Access Compliance Report

Public Rights-of-Way

(Curb Ramps)

Intersection ID: 26417	Main Street: BONNIE BUTLER_WY	Cross Street: RHETT BUTLER_PL	Location: NE
ADA ID: 2BC364BE8DAD	Ramp Type: BlendTrans1	Initial Pass/Fail: Pass	Overall Compliance: No
Severity Score: 5			
Codes/Mitigation Info/Possible Solution		Field Measurements/Component Compliance

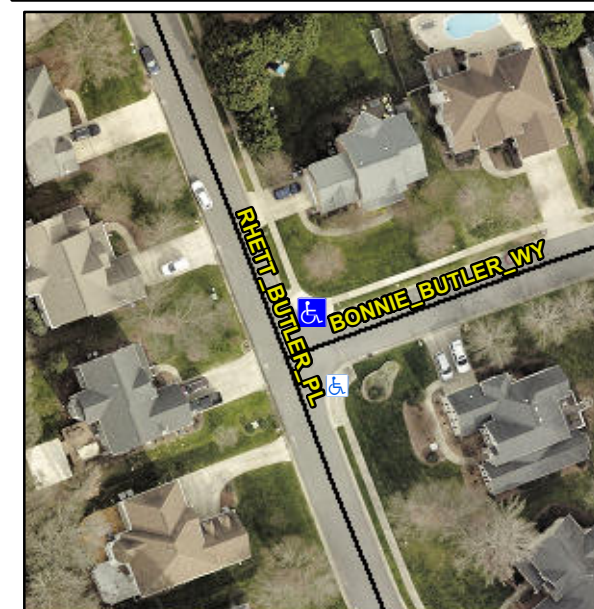
R305.2, R304.5.4, R304.5.3

Compliance	Description	Data	Compliance	Description	Data
N/A	Ramp Length (in)	48.0	Yes	BlendTrans Slope (%)	5.0
Yes	Ramp Width (in)	48.0	Yes	BlendTrans XSlope (%)	1.3
N/A	Flare Type LT	Sloped	N/A	Flare Type RT	Sloped
Yes	Flare Slope LT (%)	1.3	Yes	Flare Slope RT (%)	2.9
N/A	Flare Traversable LT?	Yes	N/A	Flare Traversable RT?	Yes
Yes	Landing Length (in)	48.0	Yes	DWS Provided?	Yes
Yes	Landing Width (in)	48.0	Yes	DWS Contrast?	Yes
Yes	Landing Slope (%)	1.6	Yes	DWS Length (in)	24.0
Yes	Landing X Slope (%)	0.7	Yes	DWS Full Width?	Yes
N/A	Landing Curb? (Y/N)	No	No	DWS Offset (in)	8.0
N/A	Shared Landing?	No			
Yes	Gutter Ponding?	No	No	Gutter Slope (%)	8.3
Yes	Gutter Lip Ht (in)	0.0	No	Gutter X Slope (%)	2.3
N/A	Painted X Walk1?	No	N/A	Painted X Walk2?	N/A
	X Walk 1 Direction	To SE		X Walk 2 Direction	N/A
	X Walk 1 Width (in)	N/A		X Walk 2 Width (in)	N/A
	X Walk 1 Slope (%)	2.4		X Walk 2 Slope (%)	N/A
	X Walk 1 X Slope (%)	2.2		X Walk 2 X Slope (%)	N/A

N/A	Ramp inside XWalk1?	N/A	N/A	Ramp inside XWalk2?	N/A
	Road Slope (%)	2.2		Clear Space?	Yes
	Road X Slope (%)	2.4	N/A	Clear Space to XWalk (in)	N/A
Yes	Any Obstructions?	No	Yes	Storm Grate/Utility Hazard?	No
	Obstruction Type			Storm Grate/Utility Type	
		N/A			N/A
			Yes	Surface Condition? (G/P)	Good
			Yes	Curb Slope (%)	5.3

Remove & Replace Detectable Warning System. Remove & Replace Gutter.
